Project	IEEE 802.16 Broadband Wireless Access Working Group < http://ieee802.org/16 >	
Title	Various Editorial Corrections	
Date Submitted	2003-07-17	
Source(s)	Varun Jeoti	varun_jeoti@petronas.com.my
	Micheal Drieberg	mckareb@yahoo.com
	Yew Kuan Min	yewkuanmin@yahoo.com
	Mohd. Noh Karsiti	nohka@petronas.com.my
	Mohd. Zuki Yusoff	mzuki_yusoff@petronas.com.my
	Wireless Communication Group, University Teknologi PETRONAS, Malaysia	
	Ron Murias,	rmurias@wi-lan.com
	Wi-LAN Inc, Calgary AB Canada	
Re:		
Abstract	Editorial Corrections for uplink pilot locations (OFDMA PHY), pilot modulation sequence (OFDMA PHY), and interleaver description clarification for OFDM and OFDMA PHY sections.	
Purpose	Editorial Corrections, clarifications	
Notice	This document has been prepared to assist IEEE 802.16. It is offered as a basis for discussion and is not binding on the contributing individual(s) or organization(s). The material in this document is subject to change in form and content after further study. The contributor(s) reserve(s) the right to add, amend or withdraw material contained herein.

Various Editorial Corrections (OFDMA, OFDM PHY layer)

Figure 128bb—Carrier allocations within each OFDMA UL subchannel

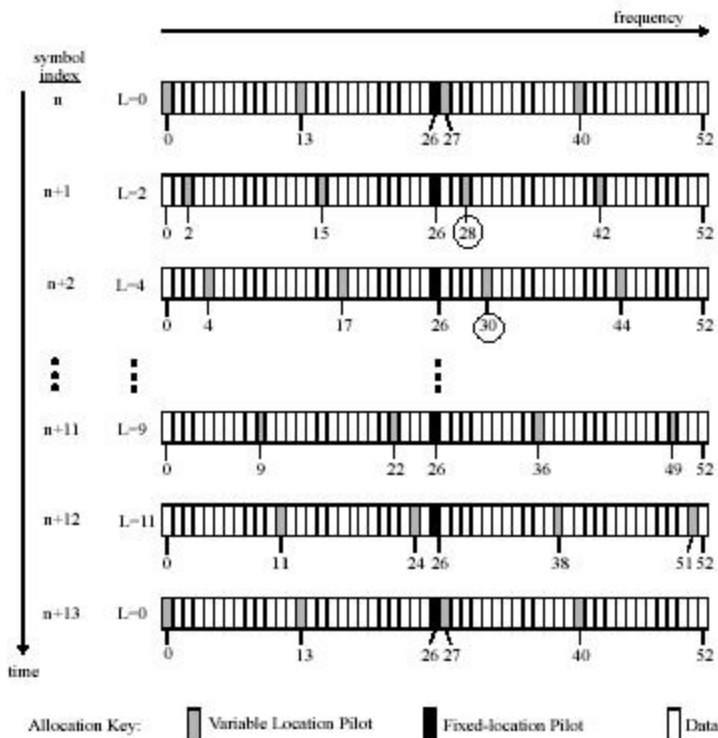
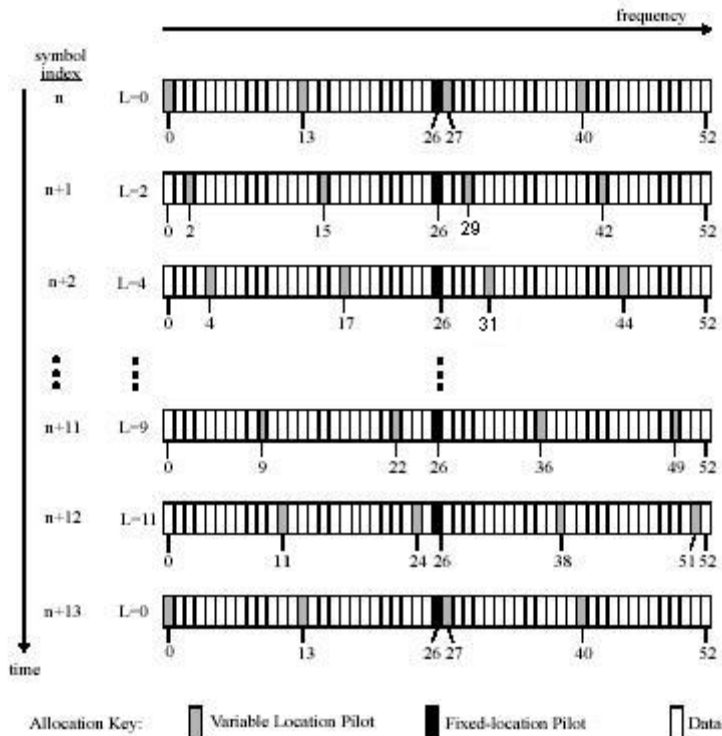
The variable location pilot's carrier number for L=2 and L=4 are incorrect (circled) it should be 29 and 31 respectively as shown in figure below.
